Re: 2022020665, Sierra Point Towers Project, San Mateo County

Subject: Sierra Point Towers Project EIR

Re: Sierra Point Towers Project Notice of Preparation (NOP)

Note that this is a modified version of Exhibit IV-17 that shows the project site. The published version of Exhibit IV-17 has the project site covered by a figure inset.

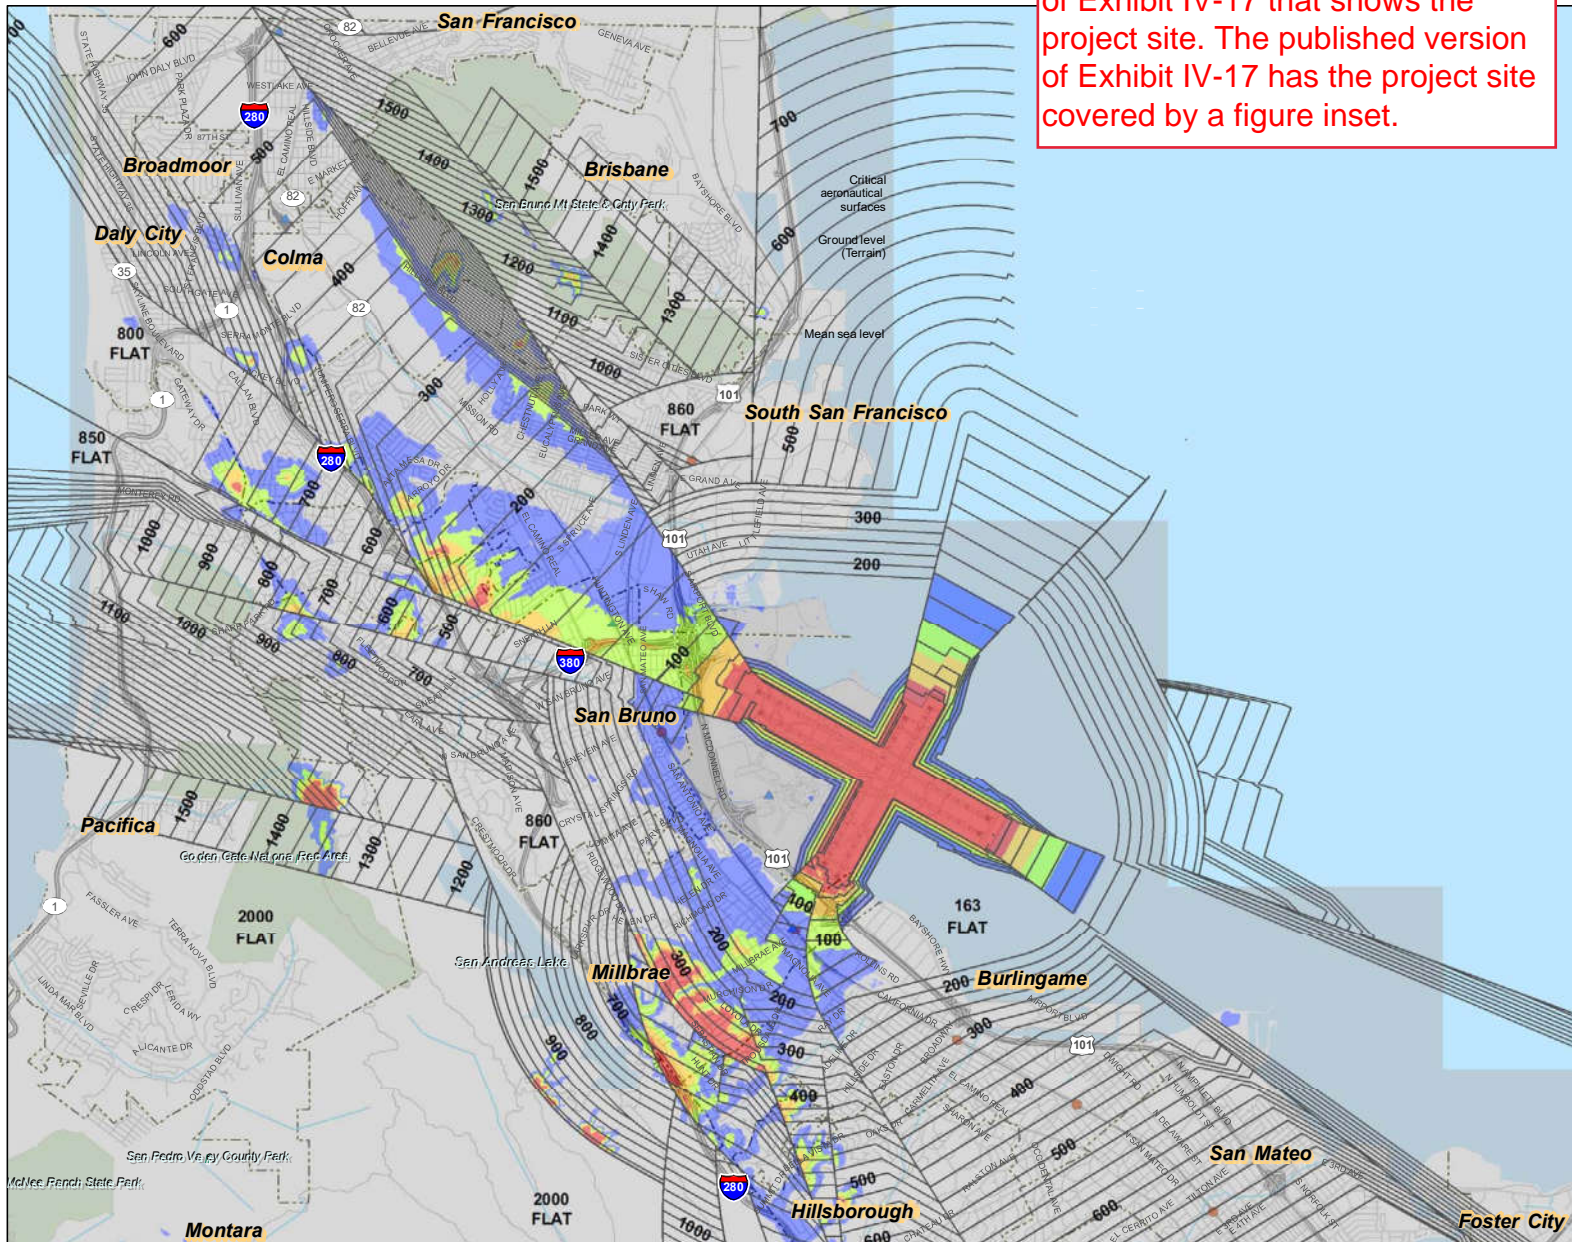
As described in Exhibit IV-17 of the SFO ALUCP (see Attachment), the critical aeronautical surfaces at the Proposed Project location would be at an elevation of at least 500 feet as defined from the origin of the North American Vertical Datum of 1988 (NAVD88). Thus, the estimated maximum elevation of the Proposed Project (218 feet NAVD88)¹ would be below the critical aeronautical surfaces and the Proposed Project would not appear to be incompatible with the Airspace Compatibility Policies of the SFO ALUCP, subject to the issuance of a Determination of No Hazard from the Federal Aviation Administration (see below) for any

¹ The total proposed elevation of GOP 4 North was not provided in the Draft SEIR. The proposed elevation was calculated by conservatively assuming 16 feet per floor. The tallest structure is 12 stories. At 16 feet per floor, the height above ground would be 192 feet. At an elevation of 20 feet, the estimated maximum elevation of any structure at the Proposed Project would be 218 feet.
